# UNITED STATES PATENT AND TRADEMARK OFFICE

APPLICATION NO.	FILING DATE	FIRST NAMED INVENTOR	ATTORNEY DOCKET NO.	CONFIRMATION NO.
10/569,317	02/22/2006	Jiecai Gan	NFE105	7888
56352	7590	03/24/2009	EXAMINER	
GLOBAL IP SERVICES			YOUNKINS, KAREN L	
7285 W. Eagle Court			ART UNIT	
Winton, CA 95388			PAPER NUMBER	
			3751	
			MAIL DATE	
			DELIVERY MODE	
			03/24/2009	
			PAPER

<b>Office Action Summary</b>	<b>Application No.</b> 10/569,317	<b>Applicant(s)</b> GAN, JIECAI	
	<b>Examiner</b> KAREN YOUNKINS	<b>Art Unit</b> 3751

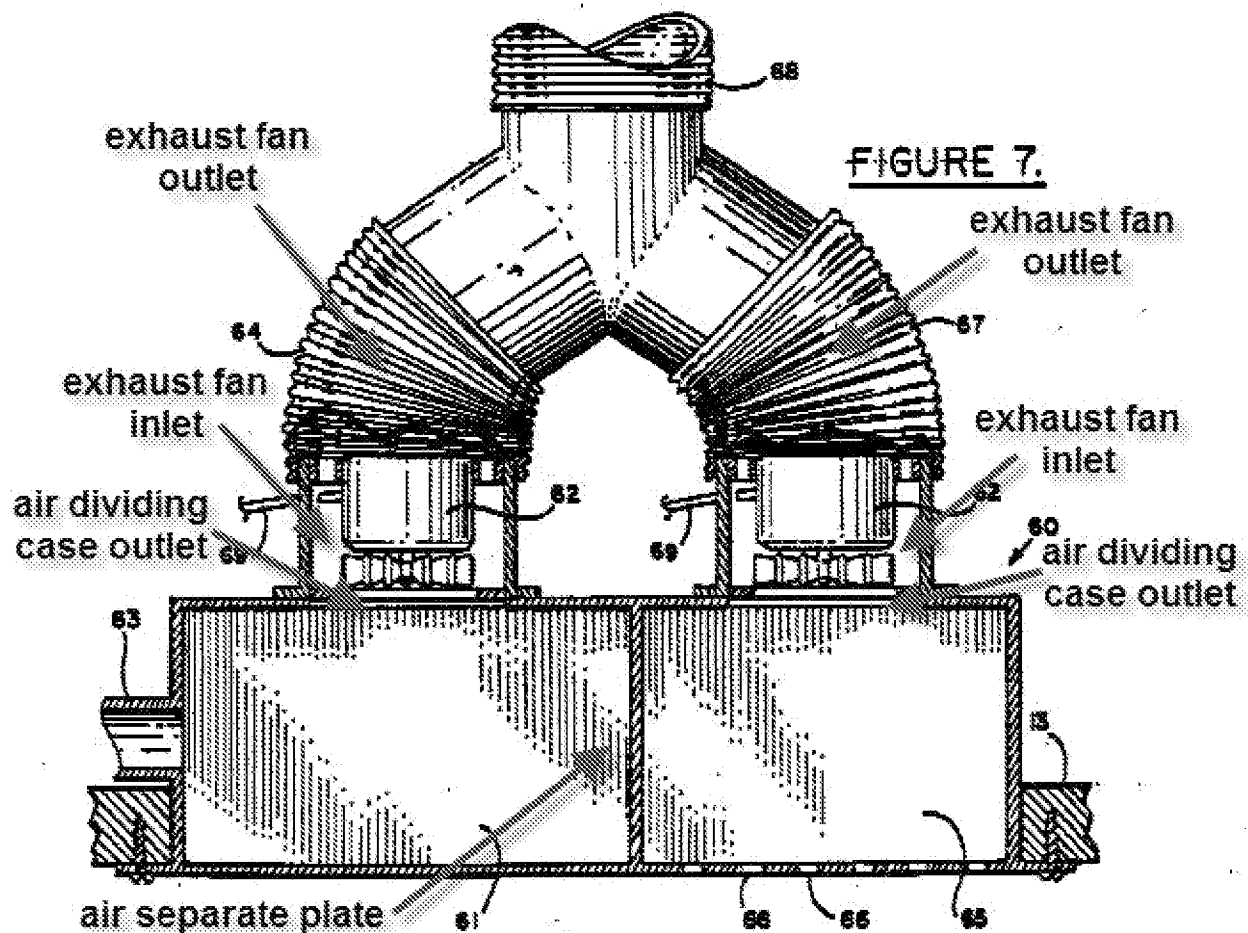
16. In reference to claims 11-14, Prisco discloses, with attention drawn particularly the embodiment disclosed in figure 7, an exhausting apparatus with an air dividing case (surrounding compartments 61 and 65) for a water closet (10) comprising an air dividing case having an inner chamber (61/65) with an outlet (see examiner annotated drawing above) and an inlet (via 63) connected with a water closet (see column 4 lines 12-14). The exhausting apparatus also includes an exhaust fan (62) with an outlet and inlet connected with the outlet of said inner chamber (see examiner annotated drawing above). The outlet of the exhaust fan is connected to the outdoors through a conduit

(67), see column 4 lines 16-22. Further, Prisco discloses the inner chamber having through holes via the screened openings 66. The screen covering the openings is 'moveable' on and off of the openings. The inner chamber has an 'air separate plate' inside of it, see examiner annotated drawing above. The 'air separate plate' divides the inner chamber into two chambers (61 and 65) such that one chamber (61) leads to the water closet (10). Prisco also discloses the use of the 'air separate plate' dividing the inner chamber into dual compartments may be required in rooms having a plurality of toilets, see column 4 lines 22-24.
